BR 3-154 ON US9 SAVANNAH ROAD & BR 3-153 ON SR1A REHOBOTH AVENUE OVER LEWES-REHOBOTH CANAL

CONSTRUCTION CONTRACT NUMBER: T201507602
FEDERAL AID PROJECT NUMBER: EBHOS-S018(13)

ADDENDA & REVISIONS	
DESCRIPTION	NAME & DATE
ADDENDUM 1 - RELOCATED TRANSFORMER PAD AT BR 3-154 SHEETS 115, 149, 160 AND 161.	RAJ 07-06-18

ELECTRICAL GENERAL PLAN AND ELEVATION

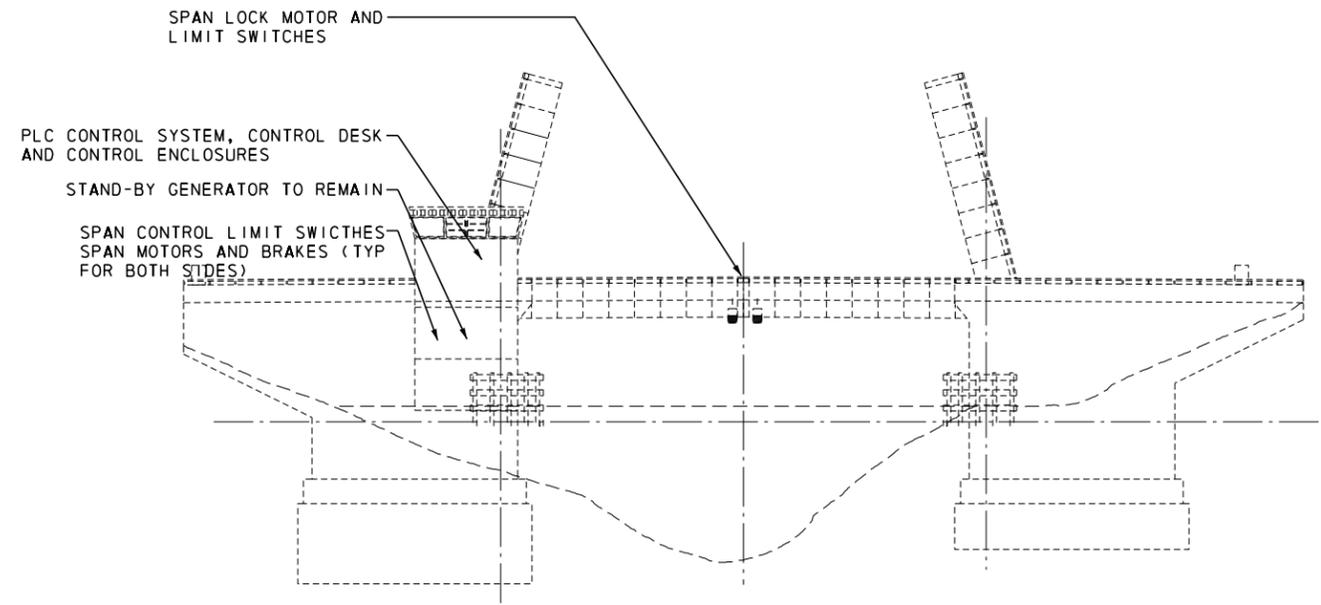
ADDENDUMS / REVISIONS	
△	MOVED TRANSFORMER (RAJ 7/6/18)

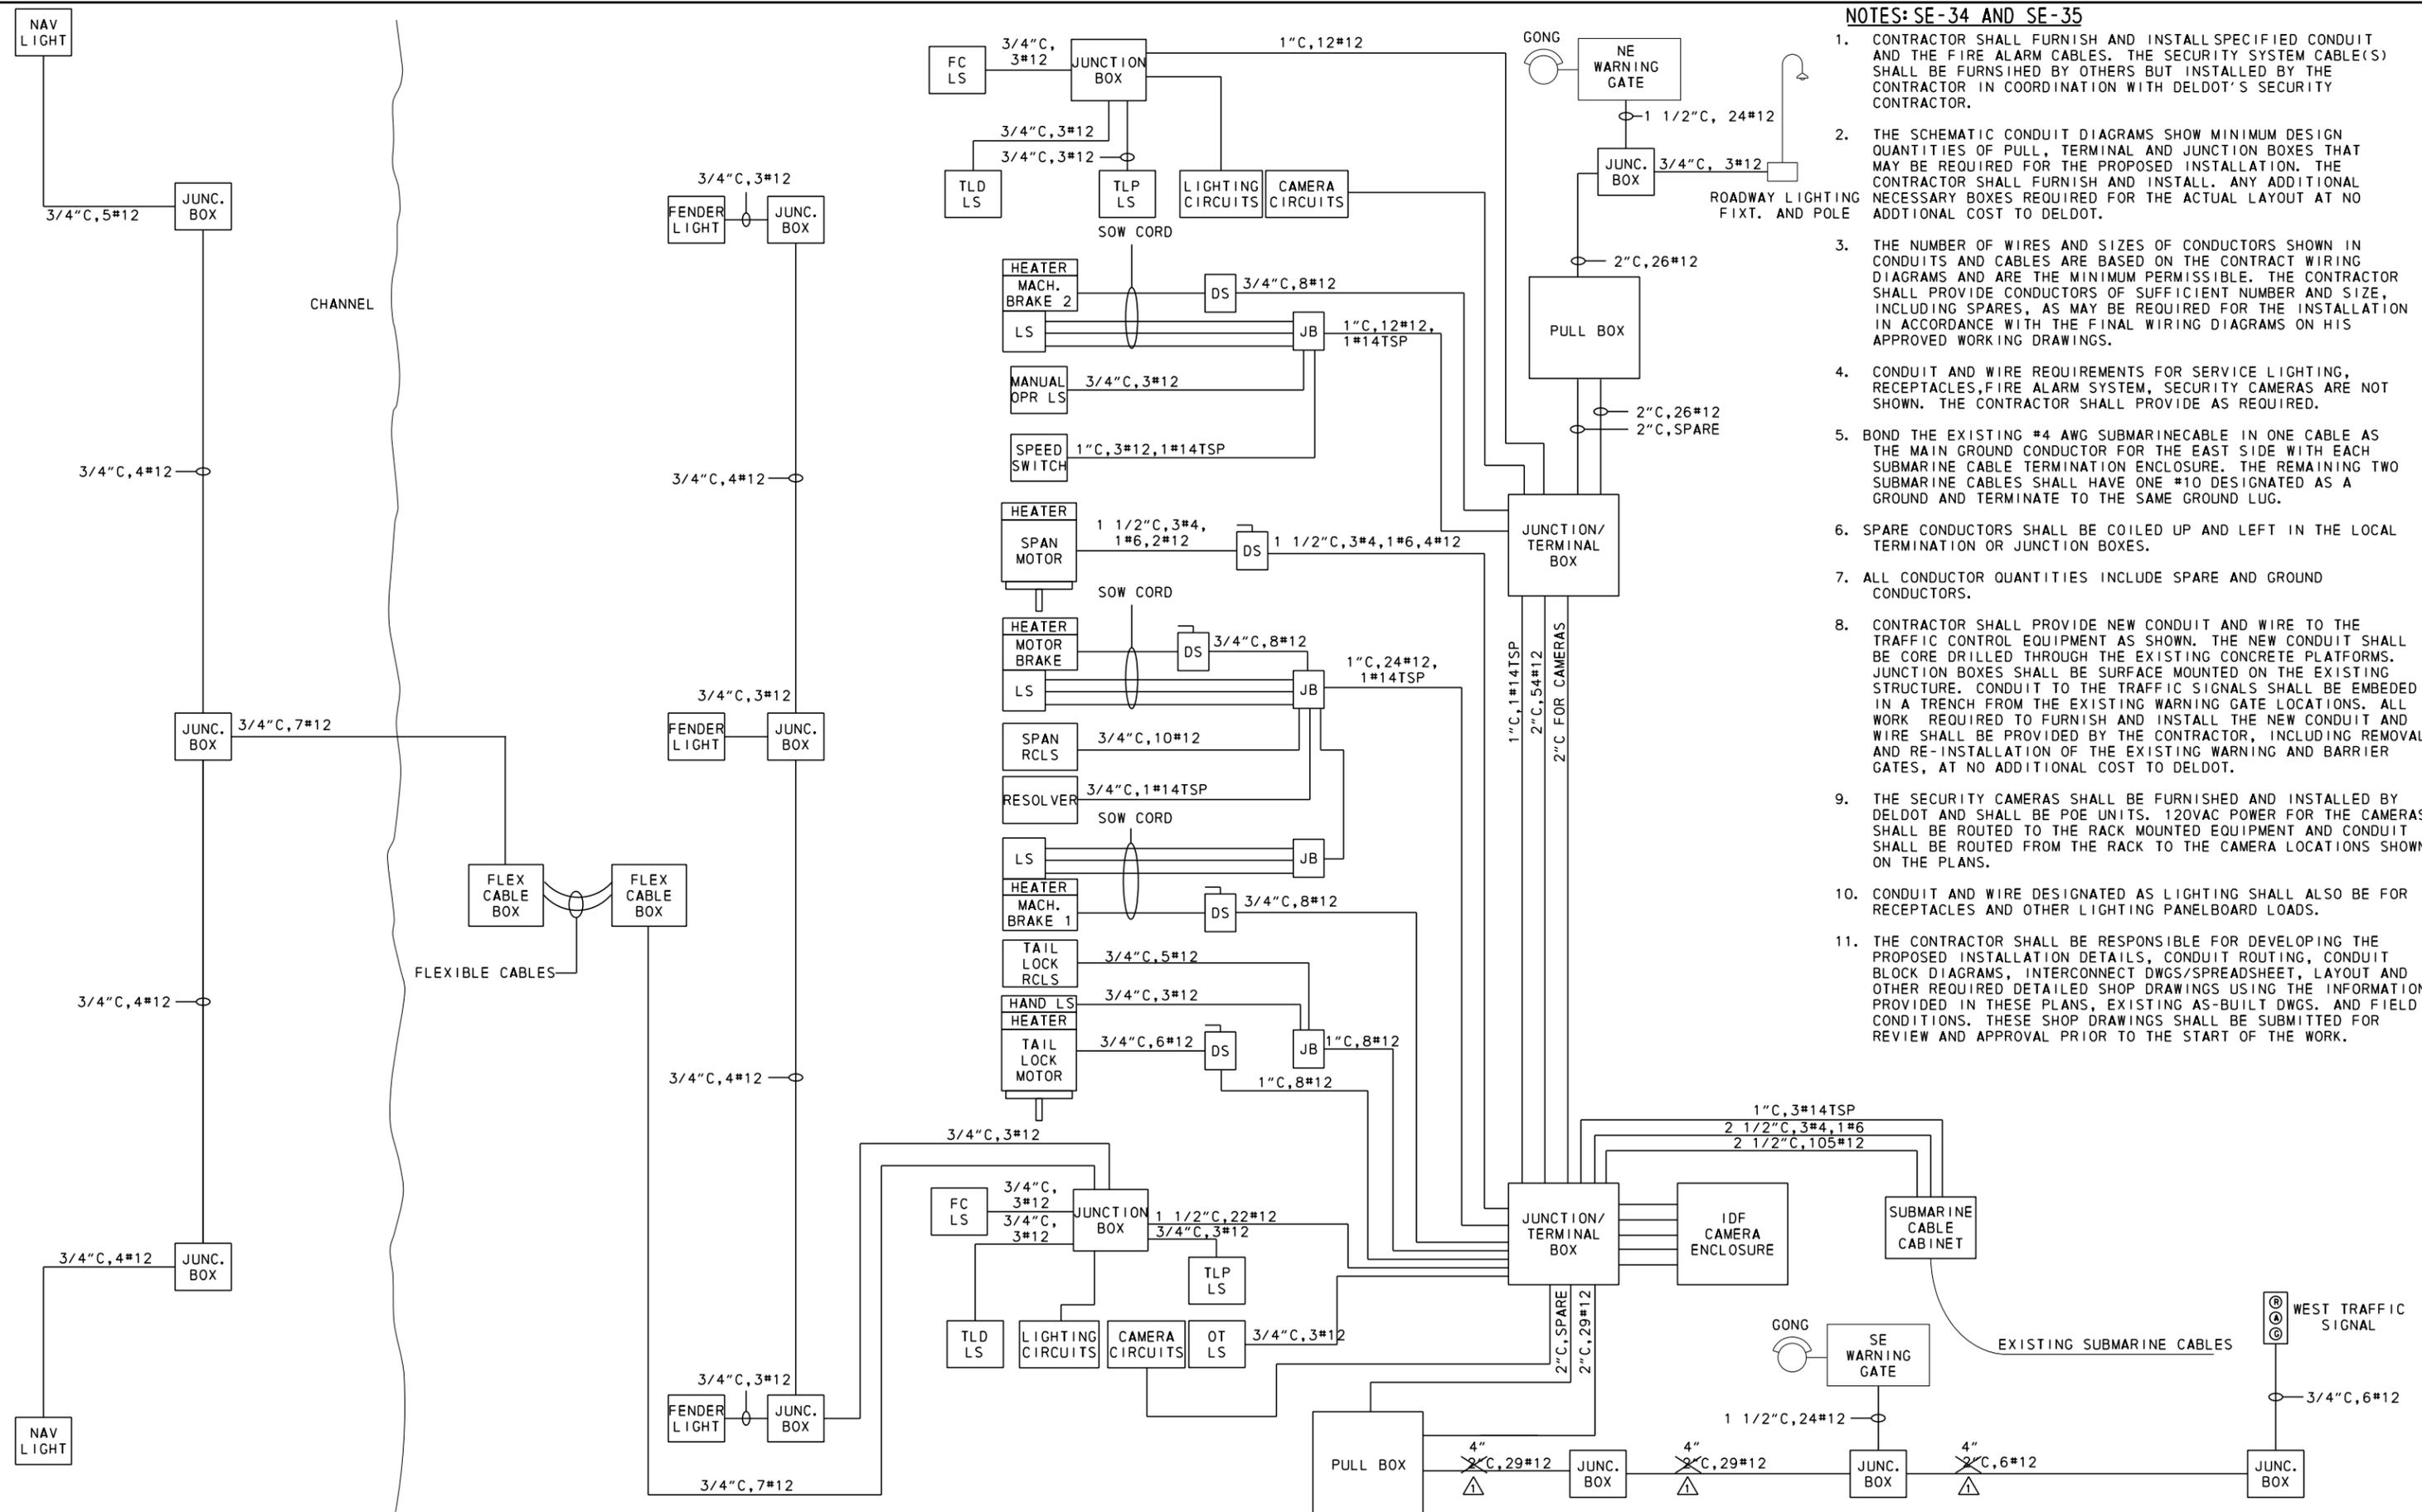
<p>DELAWARE DEPARTMENT OF TRANSPORTATION</p>	ADDENDUMS / REVISIONS		NOT TO SCALE	BR 3-154 ON US9 SAVANNAH ROAD & BR 3-153 ON SR1A REHOBOTH AVENUE OVER LEWES-REHOBOTH CANAL	CONTRACT	BRIDGE NO.	3-154	CONDUIT BLOCK DIAGRAM - EAST	SE-35
	CHANGE CONDUIT SIZE (RAJ 7/6/18)				T201507602	DESIGNED BY: MJT			SHEET NO.
					COUNTY	CHECKED BY: AHN			149
					SUSSEX				TOTAL SHTS.
					180

ELECTRICAL UTILITY LOCATION PLAN

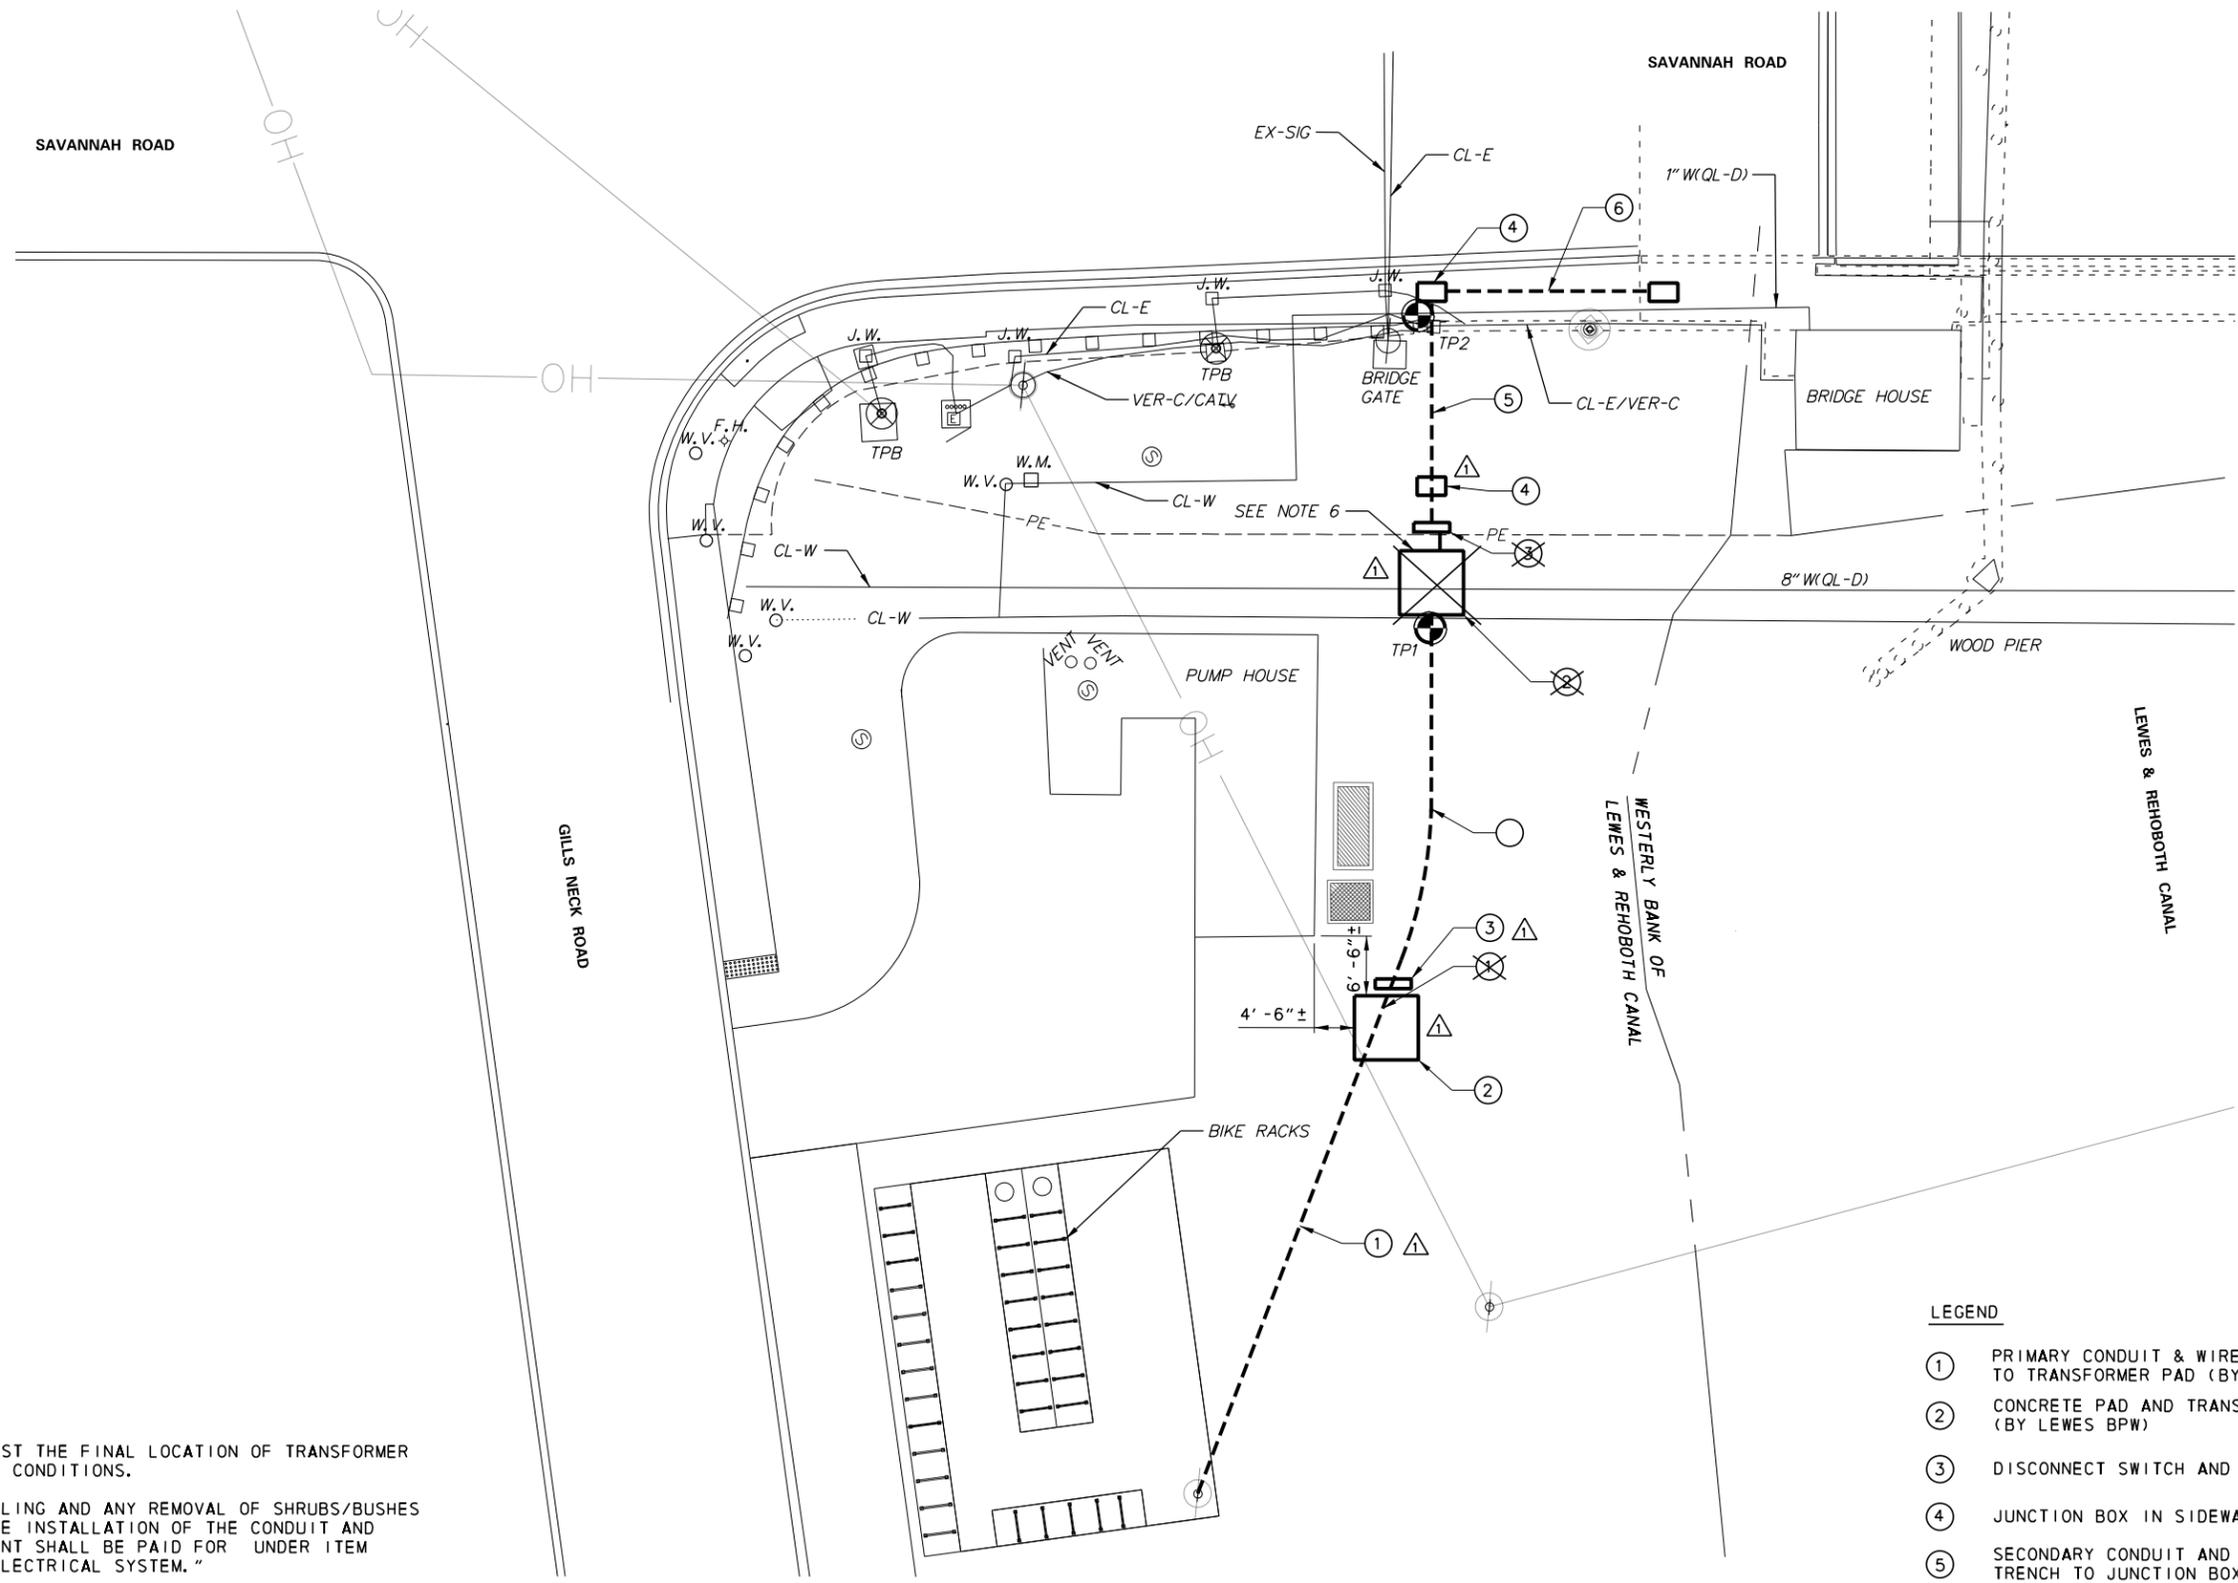
<p>DELAWARE DEPARTMENT OF TRANSPORTATION</p>	ADDENDUMS / REVISIONS		<p>NOT TO SCALE</p>	<p>BR 3-154 ON US9 SAVANNAH ROAD & BR 3-153 ON SR1A REHOBOTH AVENUE OVER LEWES-REHOBOTH CANAL</p>	CONTRACT	BRIDGE NO.	<p>SAVANNAH ROAD ELECTRICAL INCOMING SERVICE PLAN</p>	SE-46
	<p>△ MOVED TRANSFORMER (RAJ 7/6/18)</p>				T201507602	3-154		SHEET NO.
					COUNTY	DESIGNED BY: M.TINE		160
					SUSSEX	CHECKED BY: AHN		TOTAL SHTS.
							180
